**Southern Nuclear Operating Company  
Vogtle Electric Generating Plant Unit 3  
Request for License Amendment and Exemption:  
Unit 3 Auxiliary Building Wall 11 Seismic Gap Requirements (LAR-20-001)**

**Unit 3 Auxiliary Building Wall 11 Seismic Gap Requirements**

**Proposed Changes to Licensing Basis Documents  
(LAR-20-001)**

**Figure 1: Location of Nonconforming Gap between End of Annex Building Wall I.1 and the Auxiliary Building**

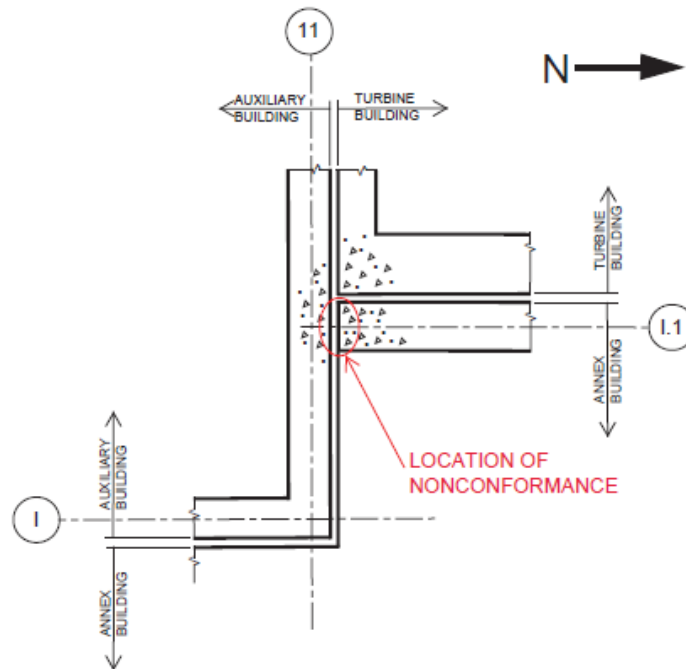
Currently, the requirement in the licensing basis for the minimum gap between the nuclear island and annex building is 3 inches, as specified in COL Appendix C ITAAC No. 3.3.00.13, UFSAR Appendix 2.5E Section 5.2, and UFSAR Subsections 3.7.2.8.1 and 3.8.5.1. UFSAR Subsection 3.8.5.1 requires that a minimum 1-inch gap be maintained between the nuclear island and annex building considering the displacements of the buildings during the SSE events. The purpose of the licensing basis requirements is to prevent interaction between the nuclear island and annex building during SSE events.

The proposed change is to relax the north-south minimum gap requirement above grade in the VEGP Unit 3 licensing basis between the nuclear island and the annex building west of Column Line I from El. 141' through El. 154' from a 3-inch gap to a 2-1/16 inches minimum gap in COL Appendix C ITAAC No. 3.3.00.13, UFSAR Appendix 2.5E Section 5.2, and UFSAR Subsections 3.7.2.8.1 and 3.8.5.1, to bound the nonconforming measured minimum gap of 2-3/16 inches in this localized area. Due to the proposed less than 1-inch reduction in the minimum gap above grade at the area of the localized nonconformance, the maximum relative displacement between the roof of the nuclear island and the annex building described in UFSAR Subsection 3.8.5.1 remains unchanged (i.e., max relative displacement less than 2-inches). The maximum relative seismic displacement between the nuclear island and the annex building is such that the reduction of the seismic gap requirement does not affect the requirement to maintain a 1-inch minimum gap during SSE events in UFSAR Subsection 3.8.5.1.

1. VEGP Unit 3 COL Appendix C (and VEGP Unit 3 plant-specific Tier 1) Table 3.3-6, ITAAC No. 3.3.00.13 Acceptance Criteria, is revised to add “; except that the minimum north-south horizontal clearance between elevations 141'-0" and 154'-0" between structural elements of the annex building and the nuclear island west of column line I is 2-1/16 inches”
